ADDENDUM

ADDENDUM NO.: 02
PROJECT NAME: Kenwood Academy Link and Mechanical (Rebid)
PROJECT NO.: 05326
CONTRACT NO.: C1602R
DATE OF ISSUE: February 29, 2024

NOTICE OF CHANGES, MODIFICATIONS, OR CLARIFICATIONS TO CONTRACT DOCUMENTS

EXISTING SITE AND DEMOLITION PLAN

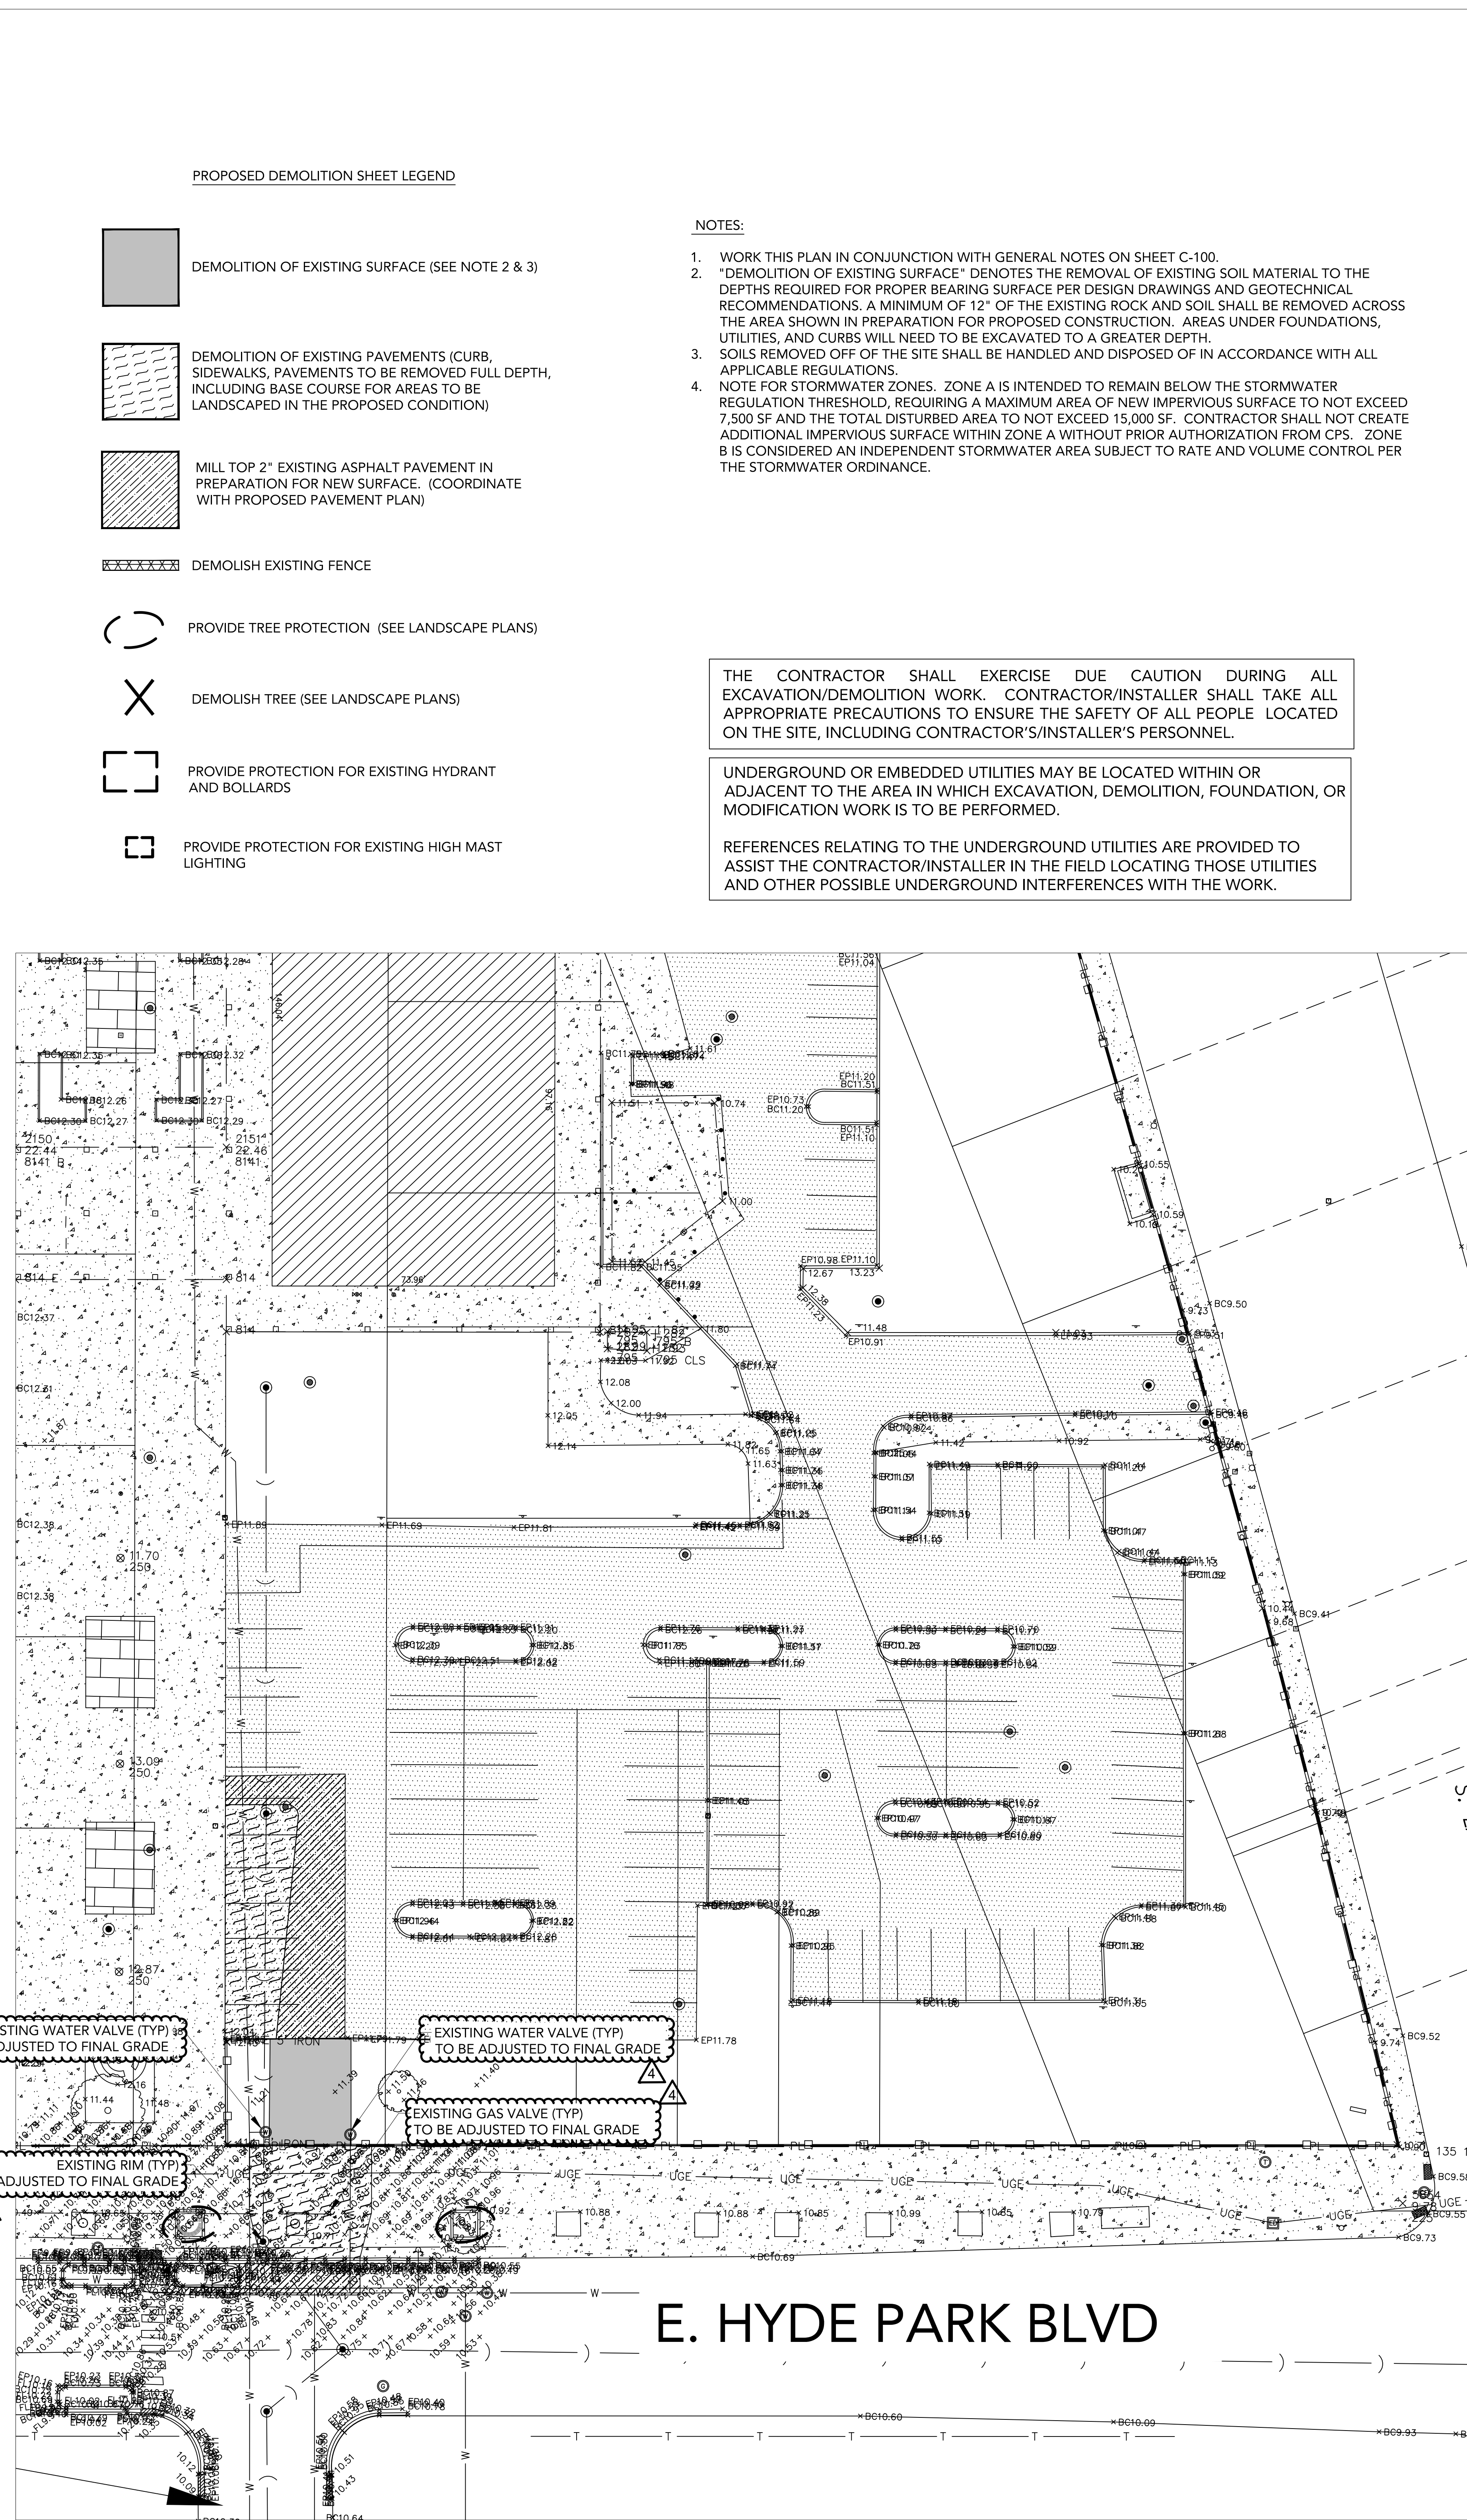
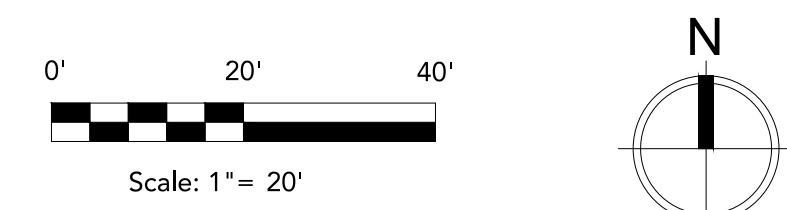
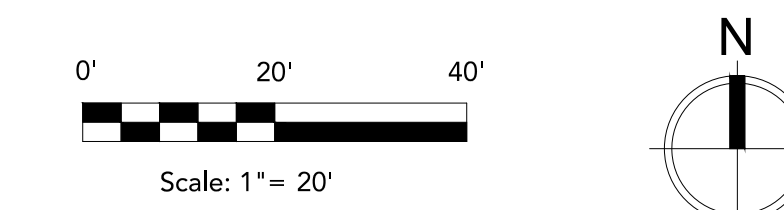
Change 2 C-102 - EXISTING SITE AND DEMOLITION PLAN; **REVISED** to add notation regarding fencing at the north parking lot

Question: During the walk thru I observed wood fencing separating the residential and the Kenwood North Lot. I also observed a wrought iron fence at the entrance to the lot and along the east of the lot bearing north and south. Neither the residential fence nor the ornamental fence is identified on Sheet C-102 as being removed, salvage, to remain.

Per sheet L104 the north entry ornamental fence is being replaced, although it is not shown as being removed on C-102. Is the existing ornamental fencing at the East, along the football field to remain or be replaced?

Question: At the new entrance, the Teacher's Lot on E. Hyde Park Boulevard, where the driveway apron is proposed there are existing utilities that are not show on C-102 or C-108. During the site visit I observed an existing gas valve box, as well, as two manhole covers. One manhole lid on the sidewalk at proposed apron location, the other right behind the ornamental fence within the proposed drive. Please advise.

Response: The fence at the west side of the north parking lot is identified to be removed per sheet C-102. The fence on the east side of the parking lot adjacent to the football field is to be removed as noted on sheet C-102 of the Contract Documents.

Response: The various utility manholes and valve boxes have been identified to be adjusted to the final grade of the driveway. Please refer to sheet C-102 and C-108 revised and included in this addendum.

Table: CIVIL UTILITY PLAN

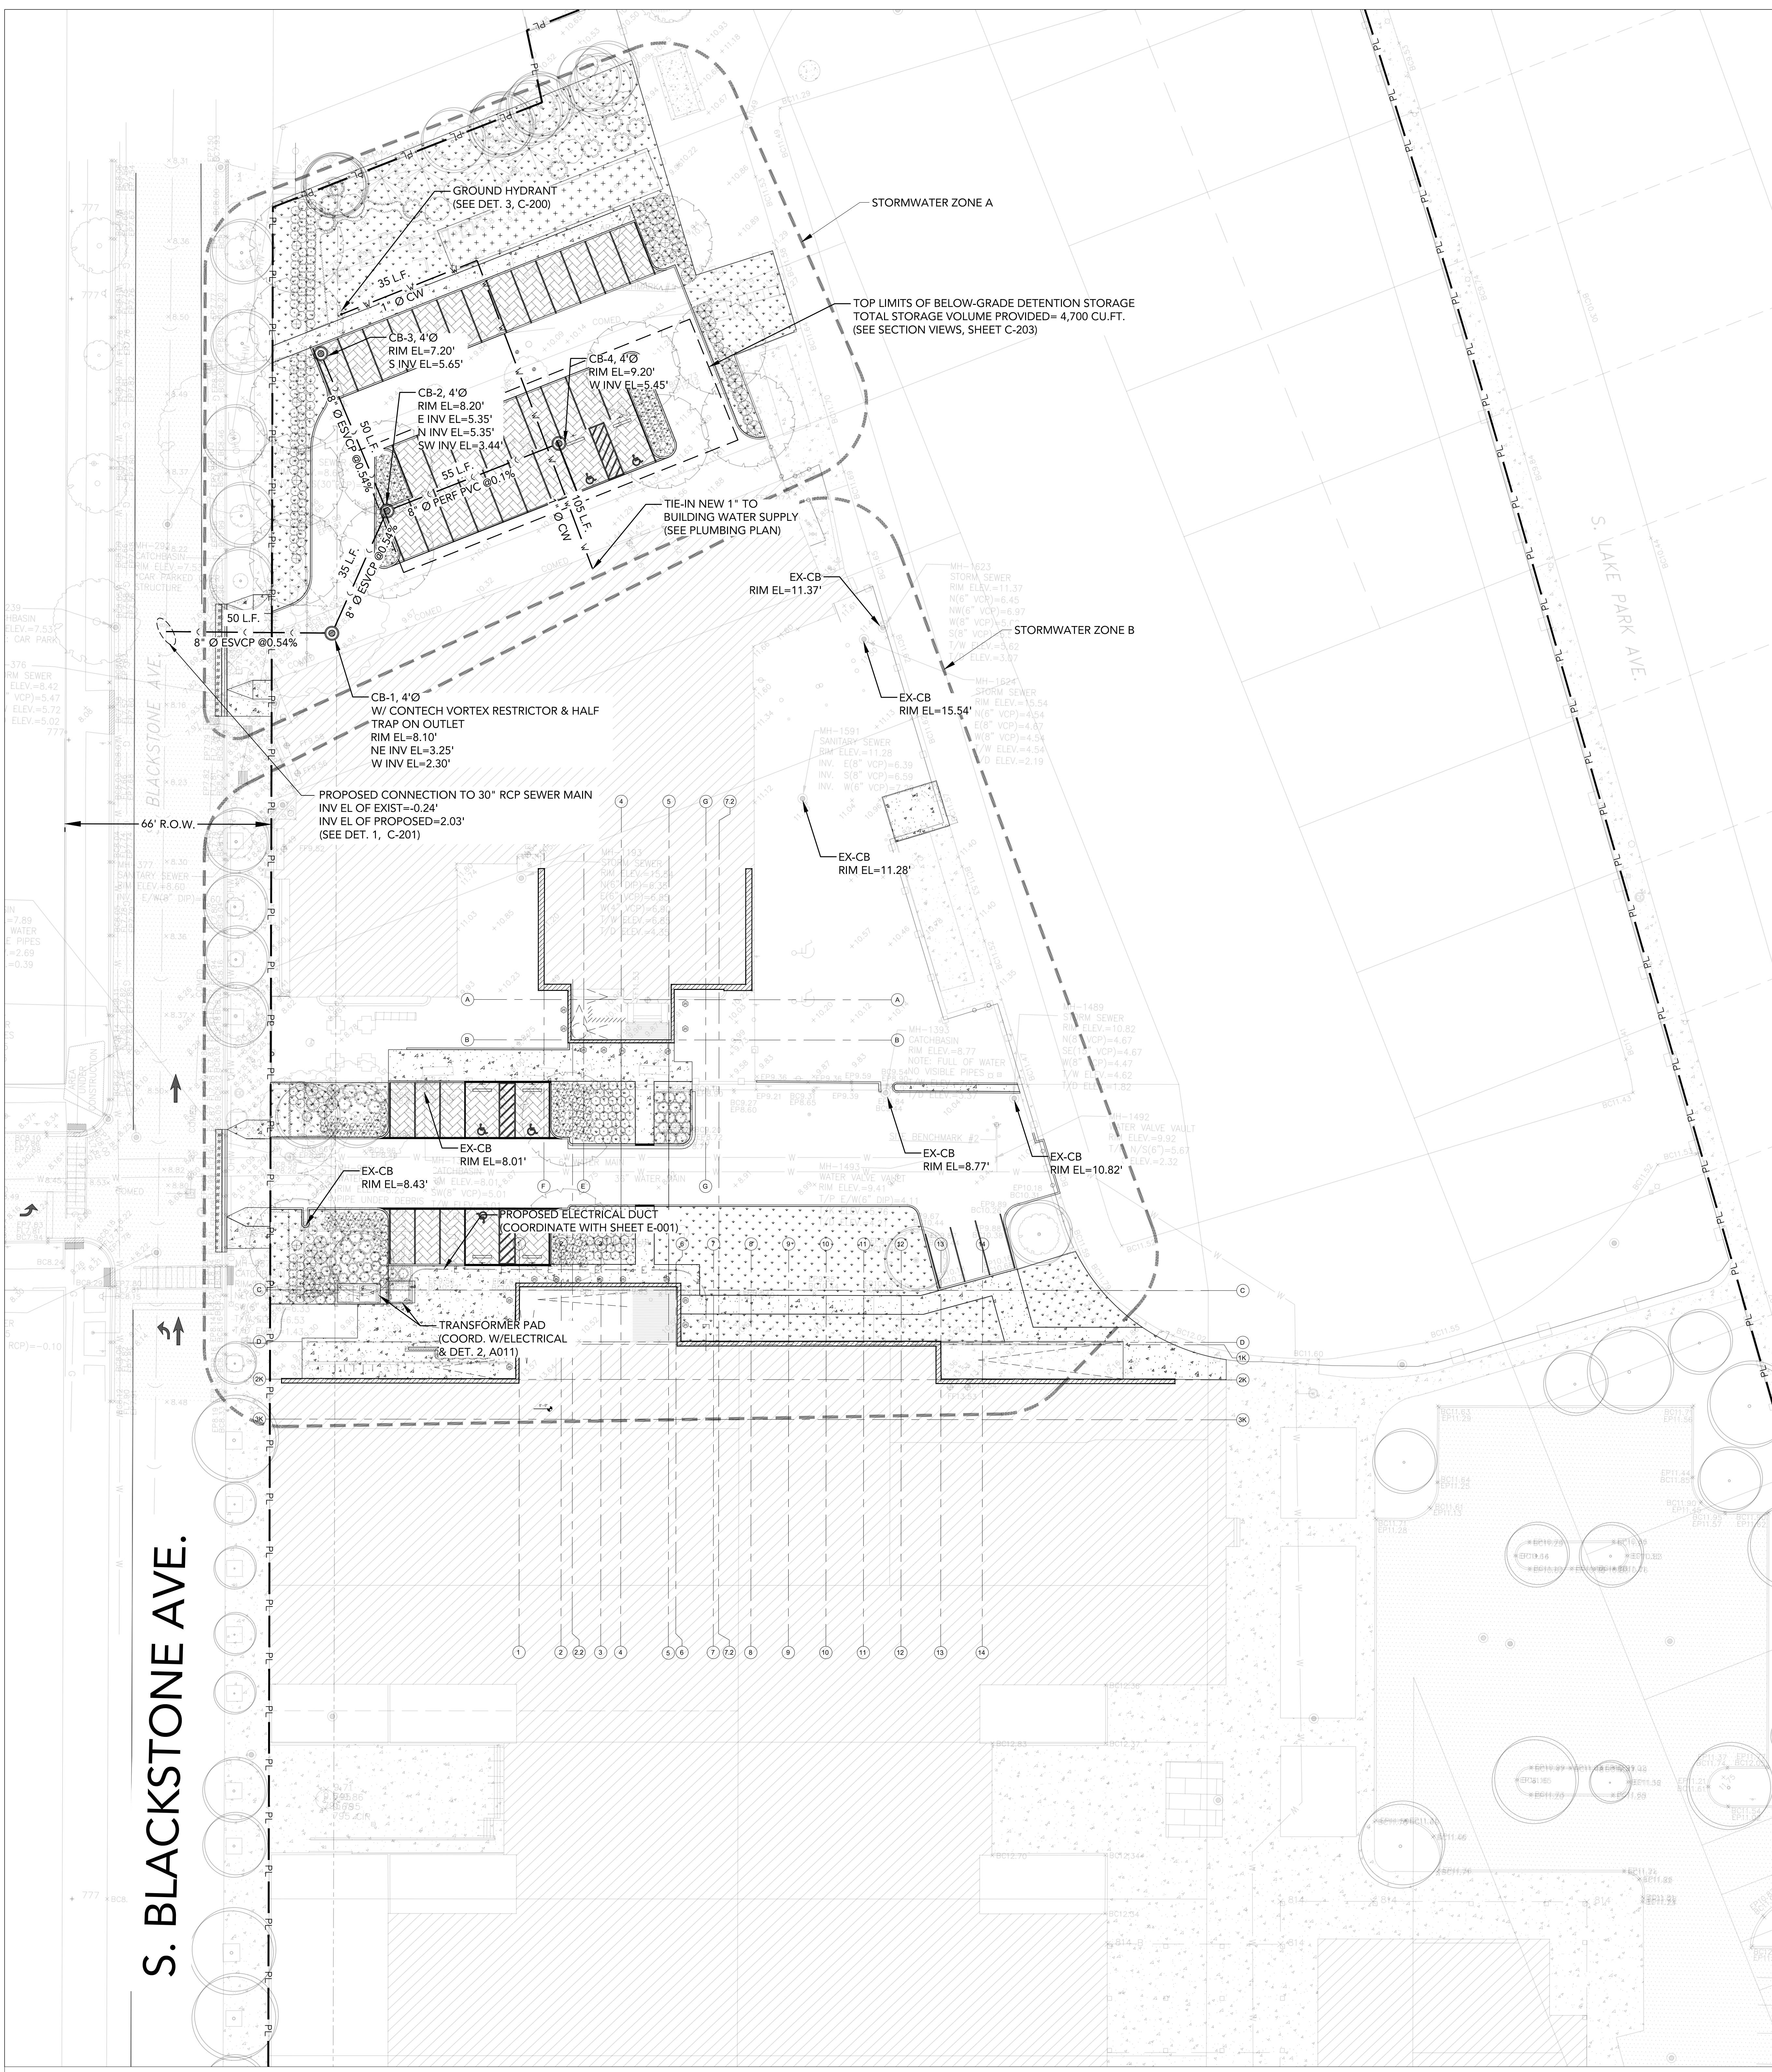
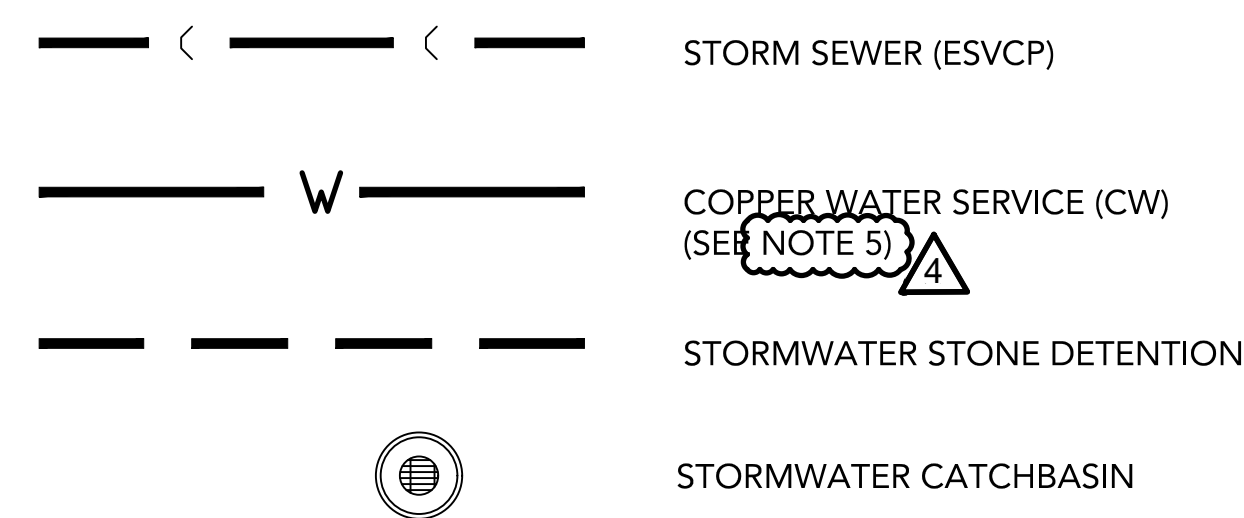
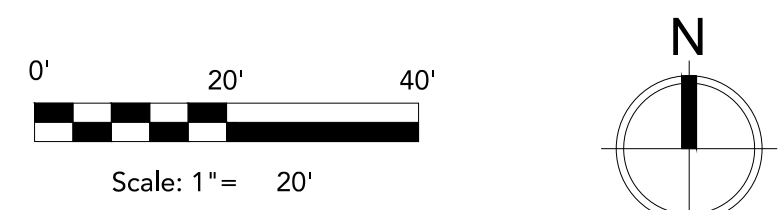
Change 3 C-105 - CIVIL UTILITY PLAN; **REVISED** to modify note in Utility Legend

Question: On sheet C-105 the legend for the copper water service reads "see note 6", there is not a note 6 on this sheet. Please advise.

Response: This should read "see note 5". Refer to note 5 on sheet C-105 revised and included in this addendum.
